S4.55 APPLICATION TO MODIFY DA

Project: PROPOSED ALTERATIONS + ADDITIONS
At: 54 HERBERT AVE. NEWPORT 2106 Lot 147 / DP 13457
For: Mr Tino Fibæk

Drawing: PROPOSED SITE PLAN
Date: June 2020
Scale: 1:200 @ A3
Drawing No. DA.1002
Issue: M/A

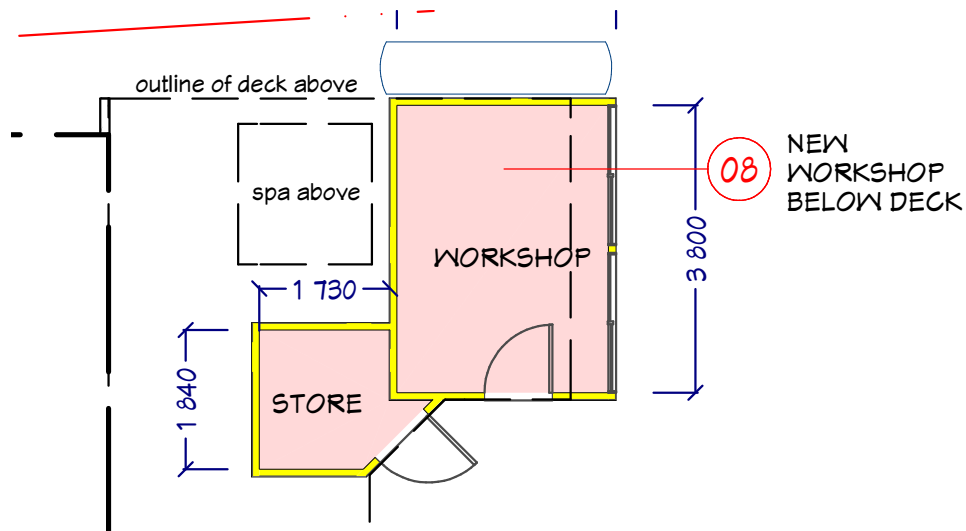
Proposed Modified Works 04 S4.55

- Existing deck to be rebuilt in steel framing (same size as original DA)
- Deck-to-garden stairs rotated 90 degrees and relocated to the east side of the deck.

- Chamfer corner to be added to deck corner where stairs were before
- Awning roof to be extended across the full width of the deck (same depth as original DA, foreseen in structural and hydraulic design)

- New Skylight to Study
- Fixed window above the double door in dining space to be relocated to living space + installed vertically
- Addition of a small freestanding fireplace in the living room (Nectre N15)

- Workshop with storage to be added under the north section of the deck.
 - Same width as the deck section
 - extending approx 55 cm out to the north below the front line of the existing deck

- sits well behind the north line of the buildings at Herbert Avenue numbers 48 and 50.
- Internal changes to bedroom, robe and ensuite + modify ensuite window
